15E ATWS Performance Evaluation

The information in this appendix of the reference ABWR DCD, including all subsections, tables, and figures, is incorporated by reference with the following departures.

STD DEP T1 3.4-1 (Figures 15E-1a, 15E-1b, 15E-1c)

Figure 15E-1a ATWS Mitigation Logic (ARI, FMCRD Run-In, RPT, Manual Initiation)

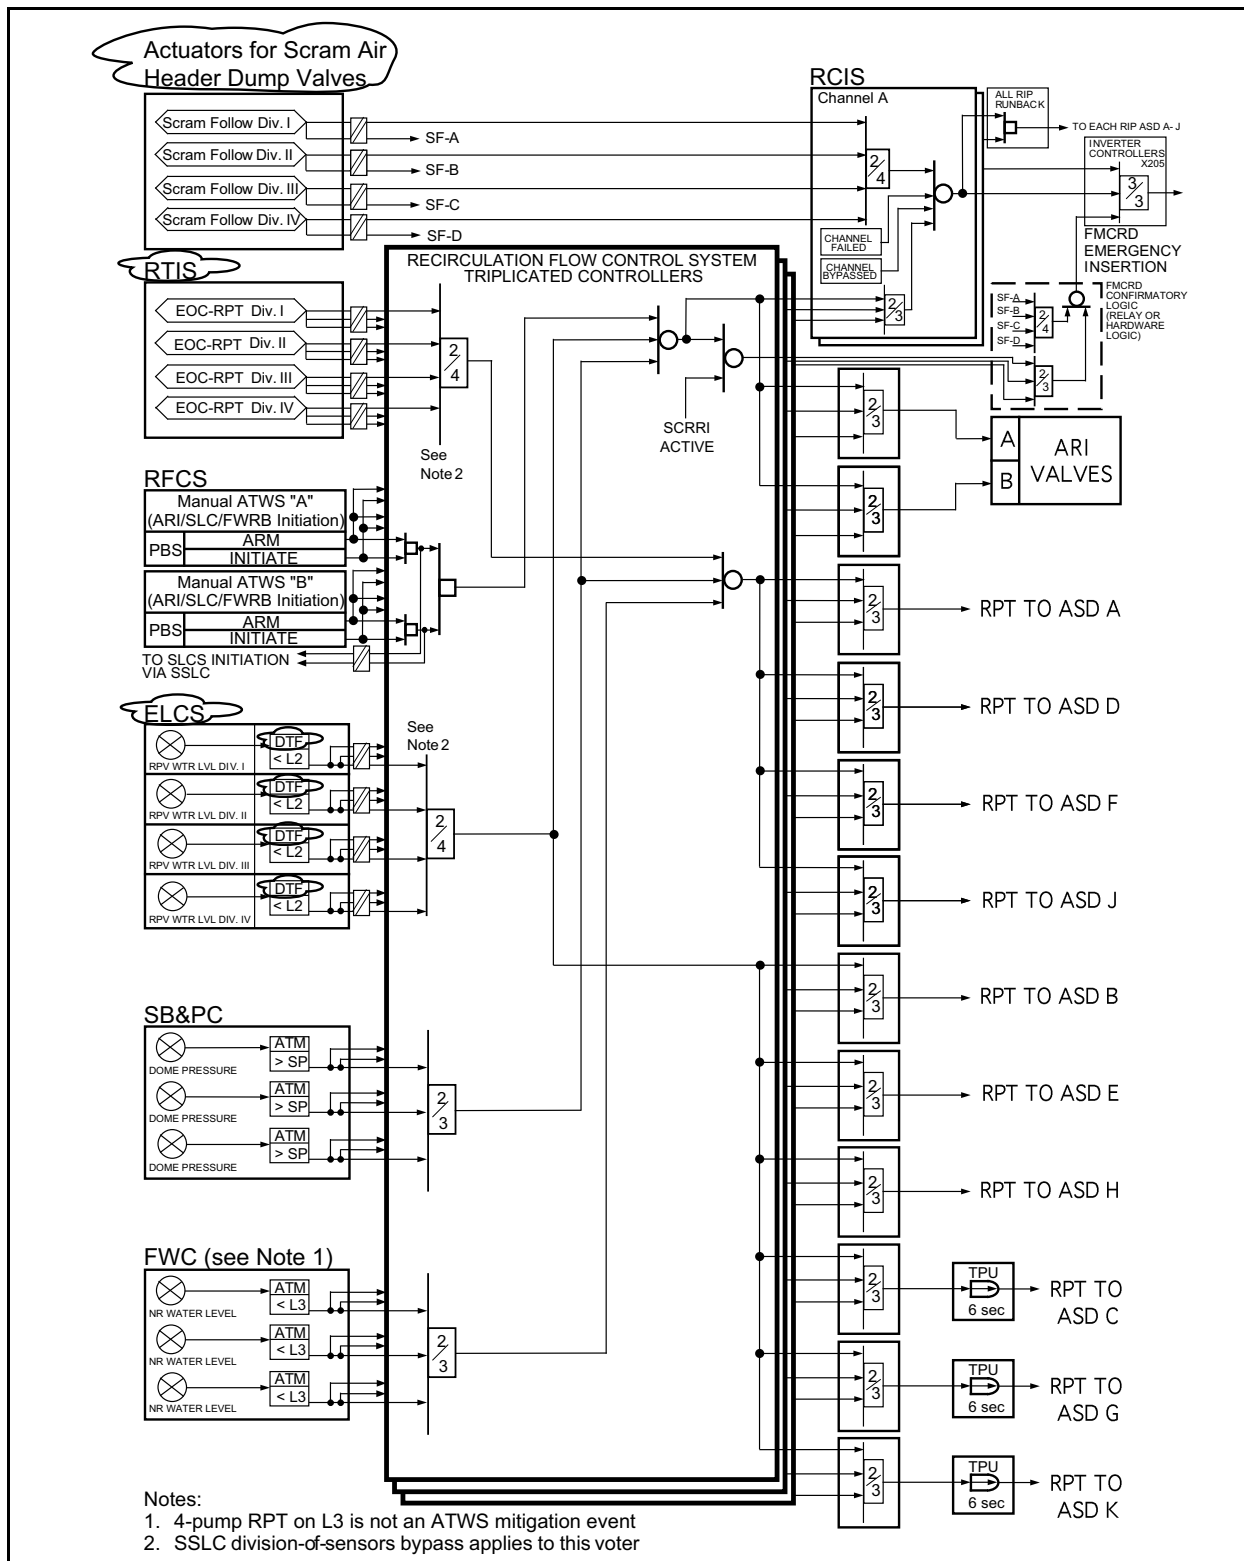
The mitigation of ATWS events is accomplished by a multitude of equipment and procedures. These include ARI, FMCRD run-in, feedwater runback, RPT, recirculation runback, ADS inhibit, and SLCS. The logic of this ATWS mitigation is presented in Figures 15E-1a, 15E-1b and 15E-1c. The following are the initiation signals and setpoints for the above response:
